PLANNING AND DEVELOPMENT SERVICES STAFF REPORT

For Planning Commission Meeting of August 18, 2015

**SUBJECT: 410 First Site Plan for City Council Approval
(408 and 412 North First Street)
File No. SP14-058**

SITE CROSS SECTION A-A
Scale: 1/16" = 1'-0" on 24" x 36"

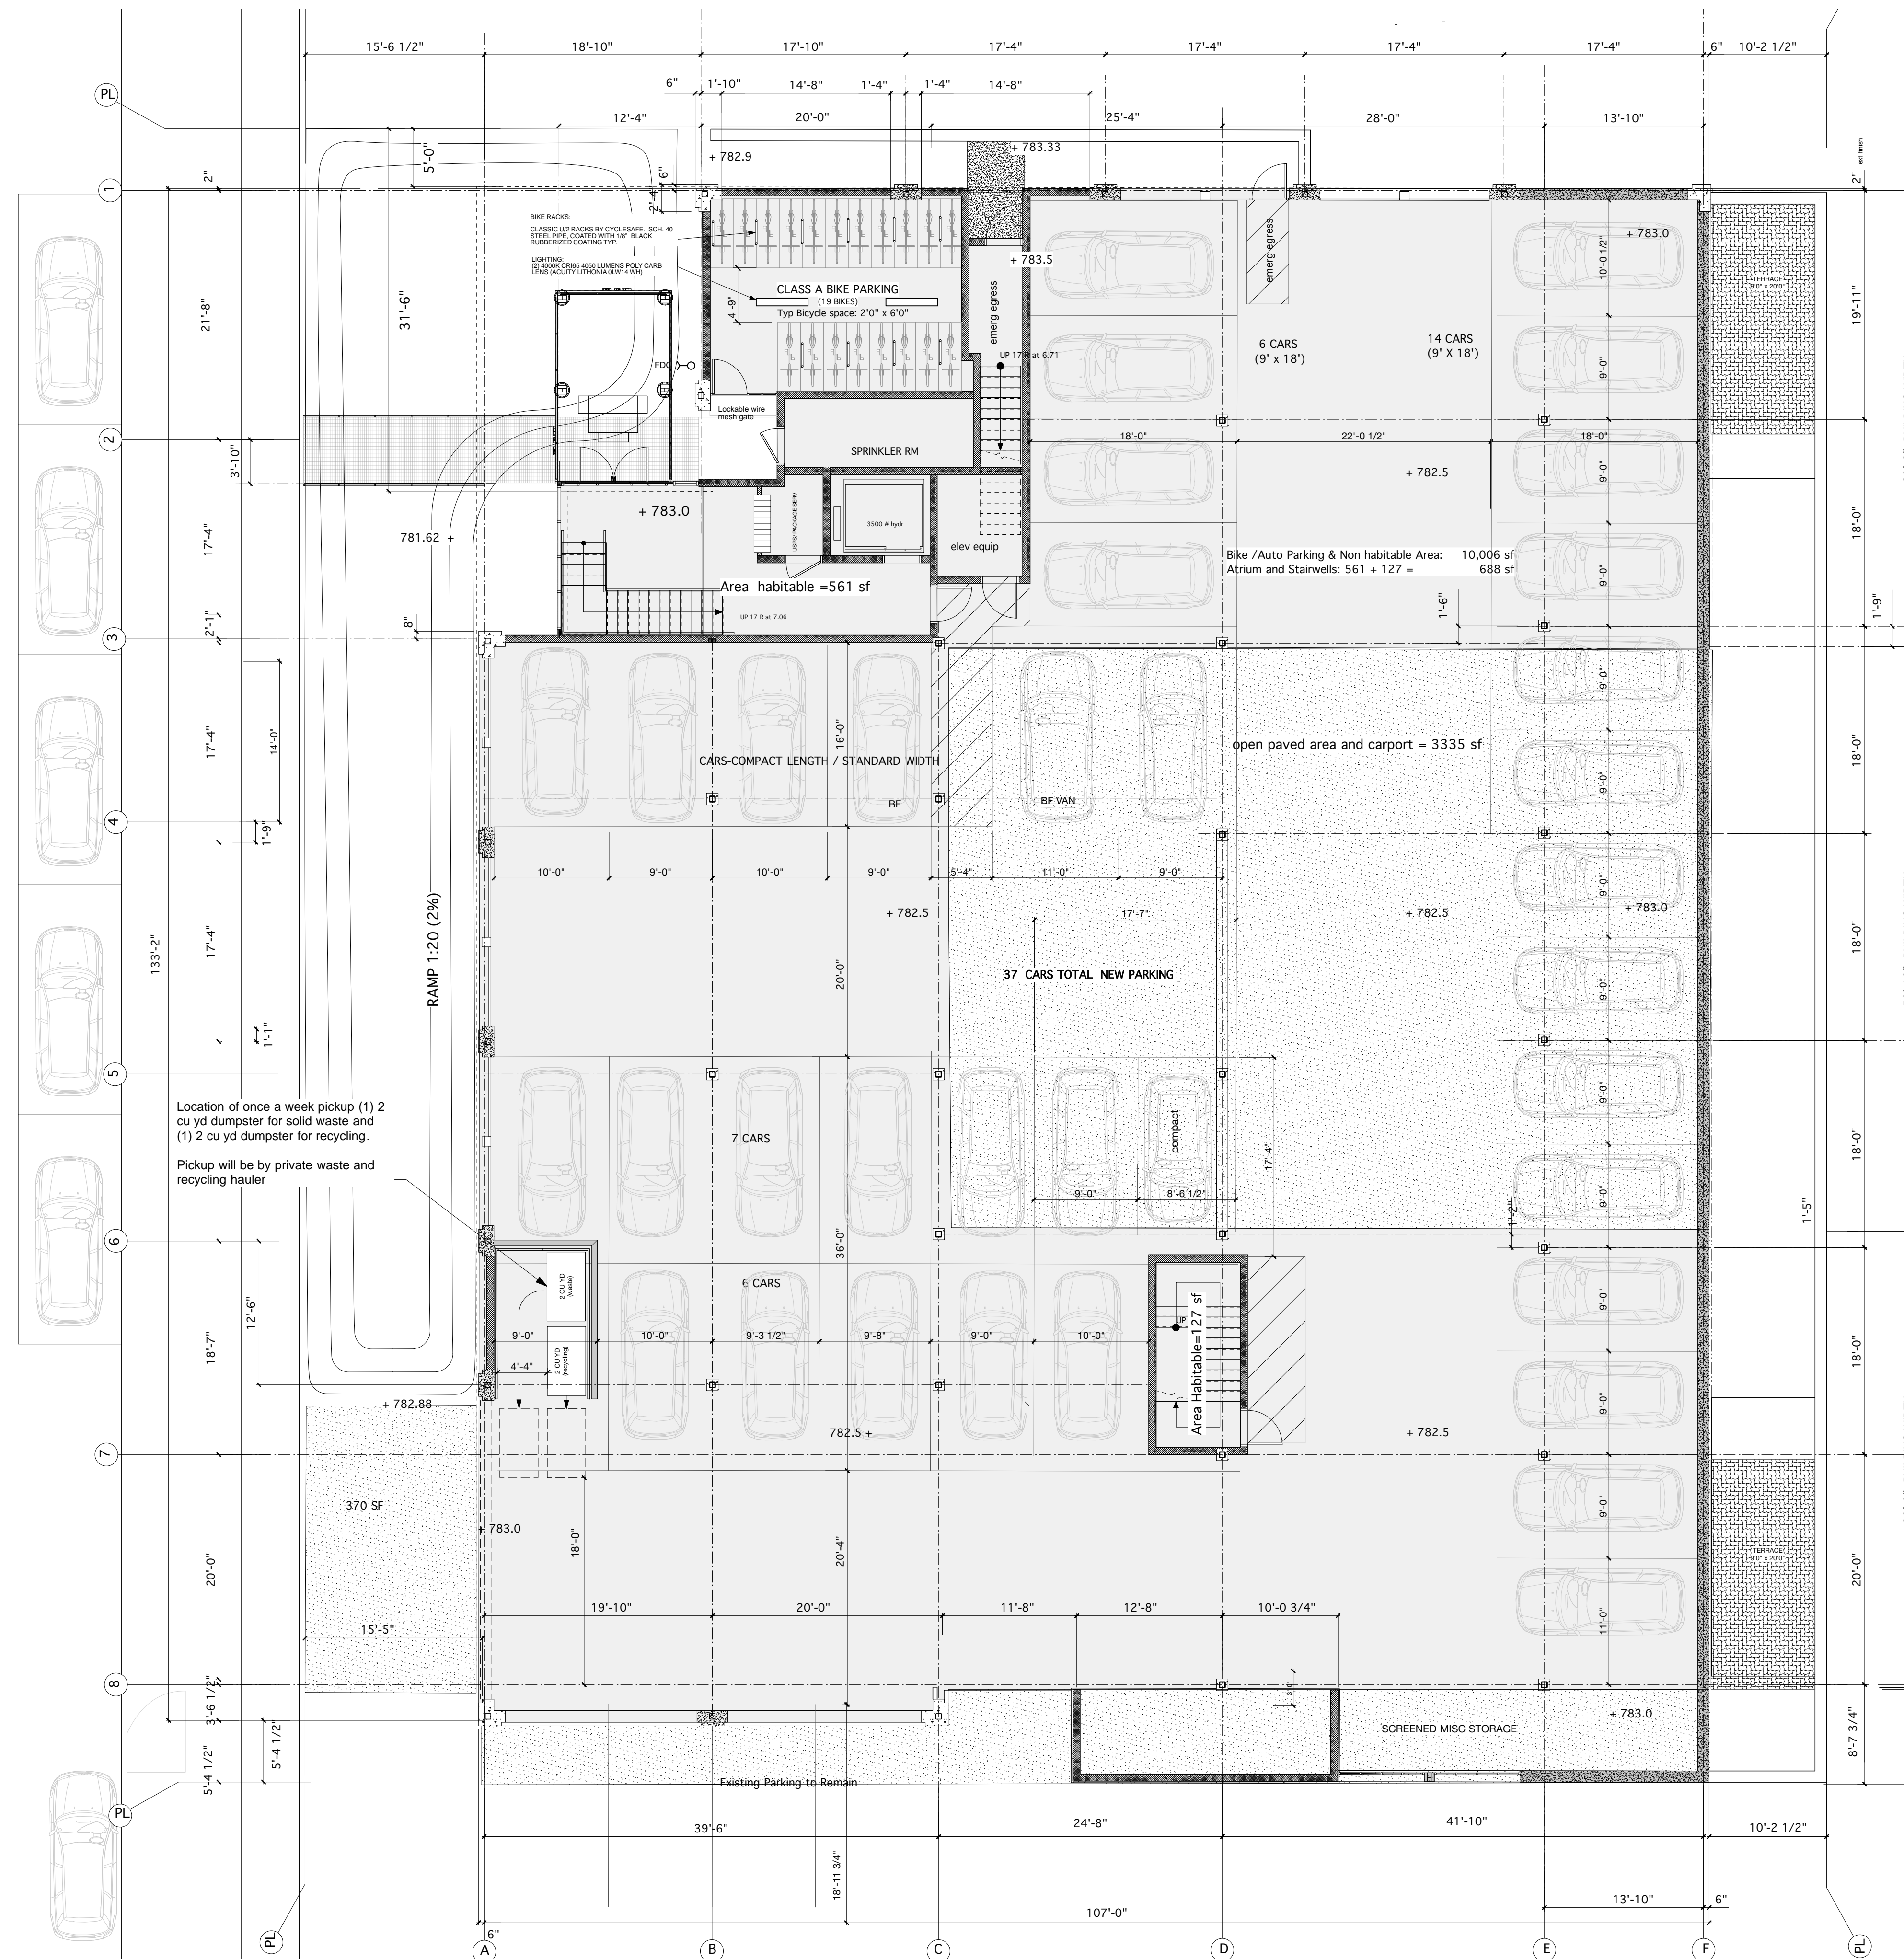
Peters asked about the average roof elevation compared with properties on Ashley and how it plays out going up the hill. He pointed out one of the goals in the Downtown Plan is reinforcing the historic buildings. He said it

Thacher reviewing the plans, said in site section A-A, she believed it was one of the larger houses on Ashley, immediately behind the structure, and while one would not be able to see the new building over the houses, one would see it in between. She said the grade is advantageous in that respect.
